MIL-C-17587B(SH)
AMENDMENT 4
2 August 1994
SUPERSEDING
AMENDMENT 3
4 March 1994

MILITARY SPECIFICATION

CIRCUIT BREAKERS, LOW VOLTAGE, ELECTRIC POWER, AIR,
OPEN FRAME, REMOVABLE CONSTRUCTION

FIGURE 13A. Time-current characteristics curve for circuit breaker types ACB-2000LRC, ACB-3200HR, and ACB-4000HR.

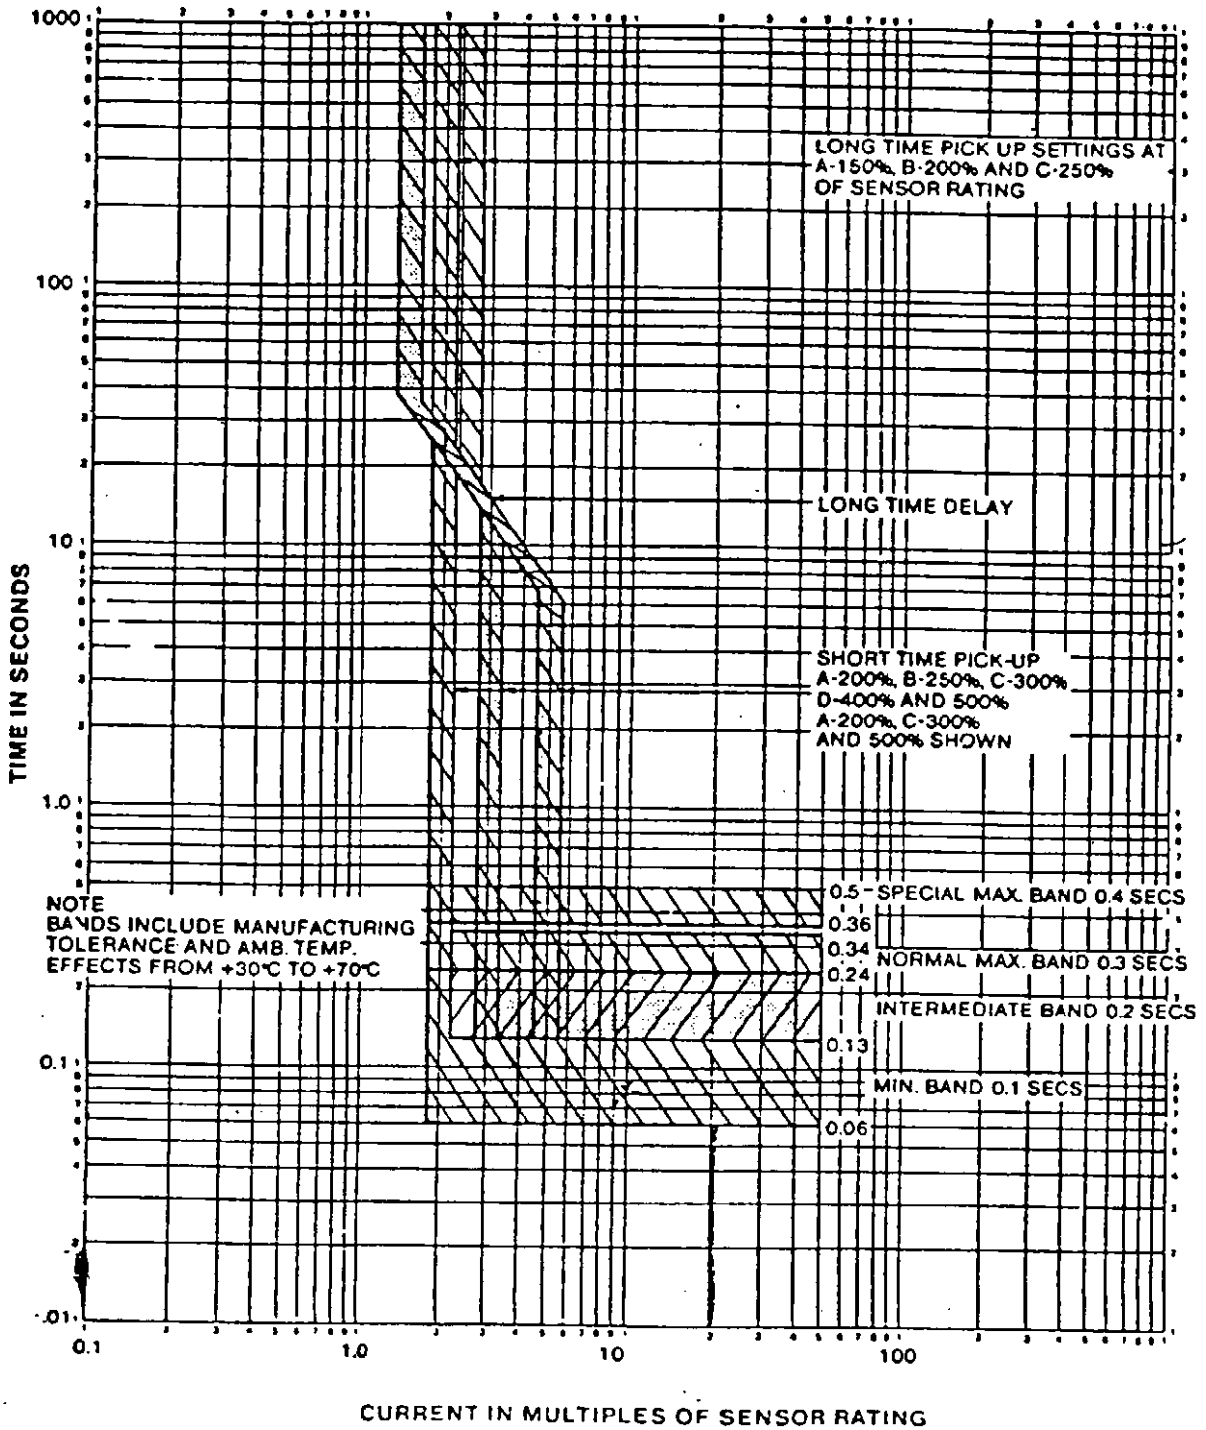
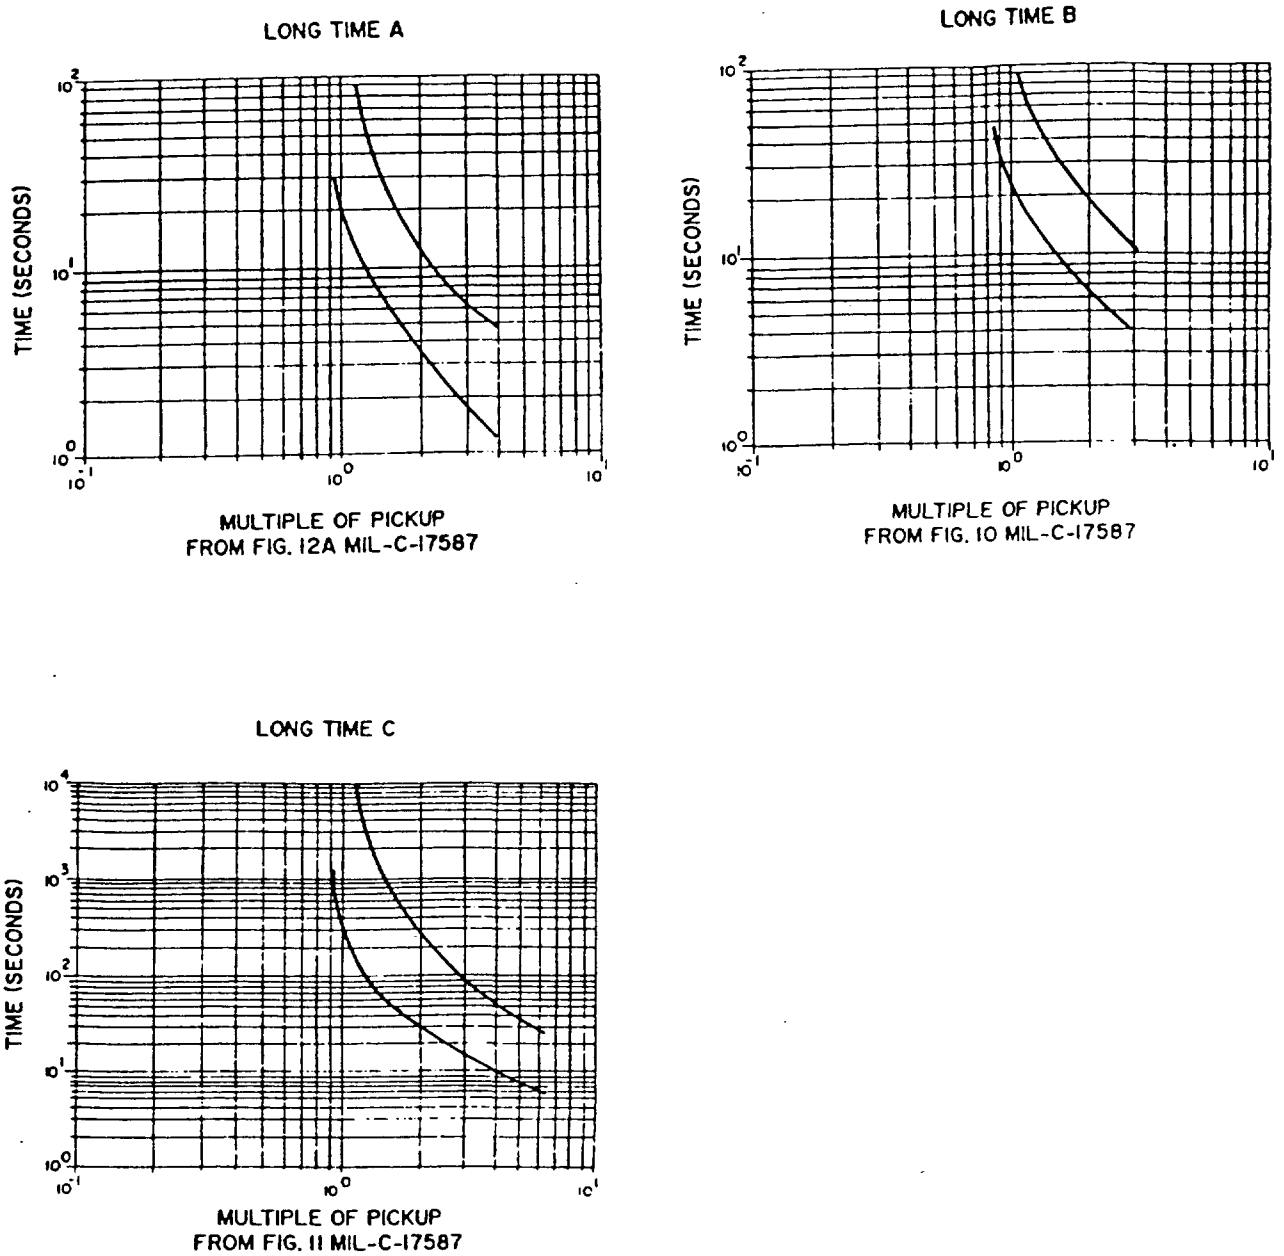
Add new figure:

FIGURE 14A. Time-current characteristics curve for circuit breaker types ACB-904LRC, ACB-1404LRC, and ACB-1604LRC.

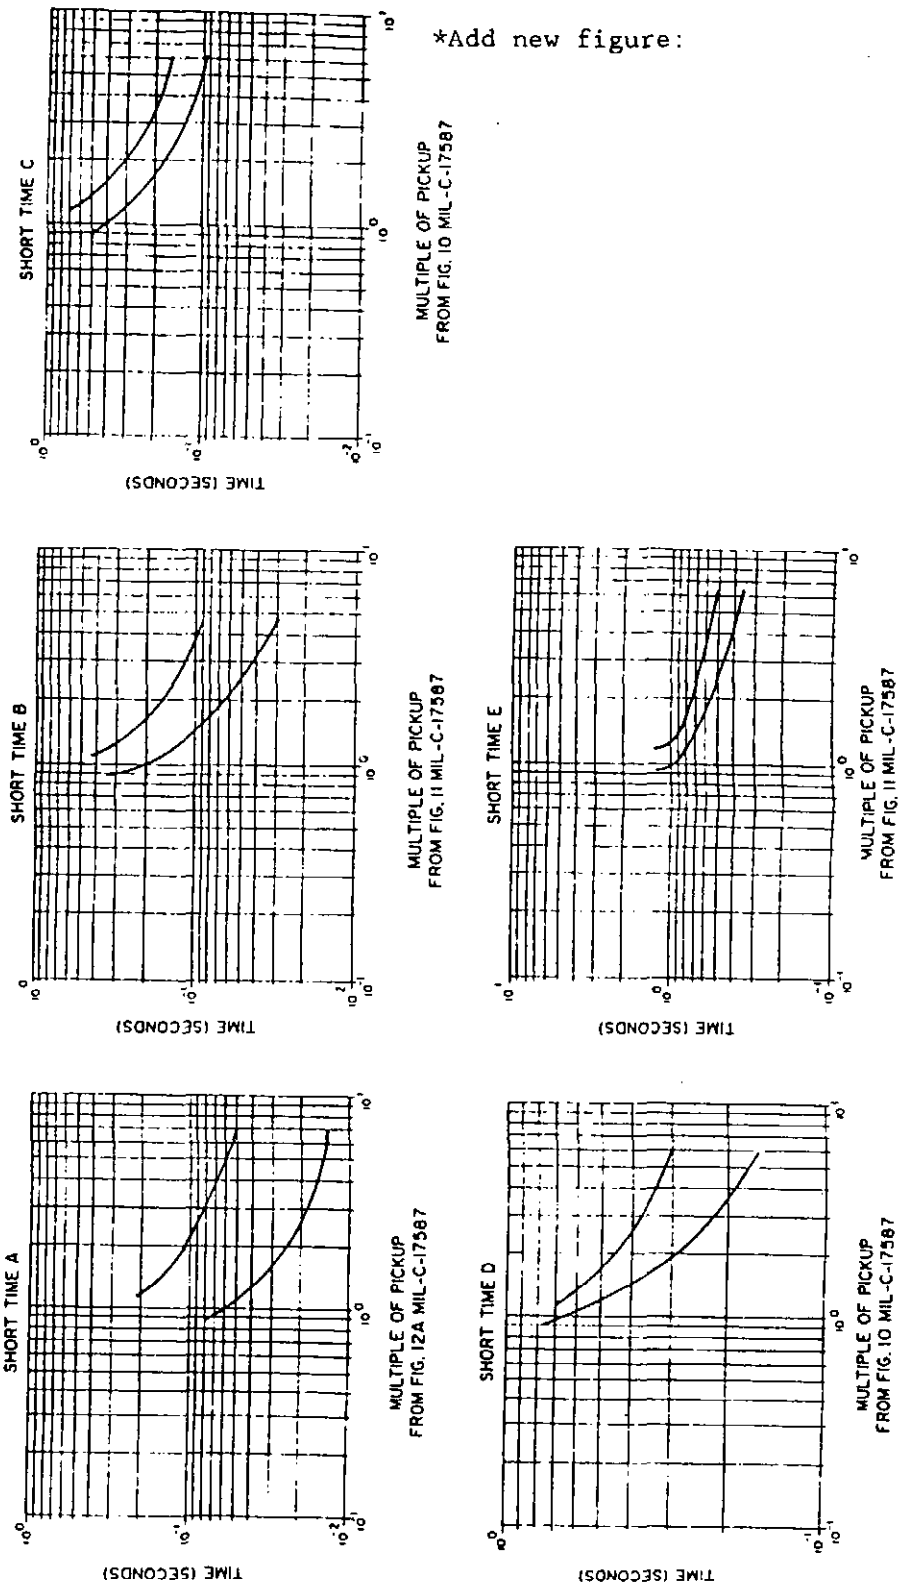
*Add new figure:
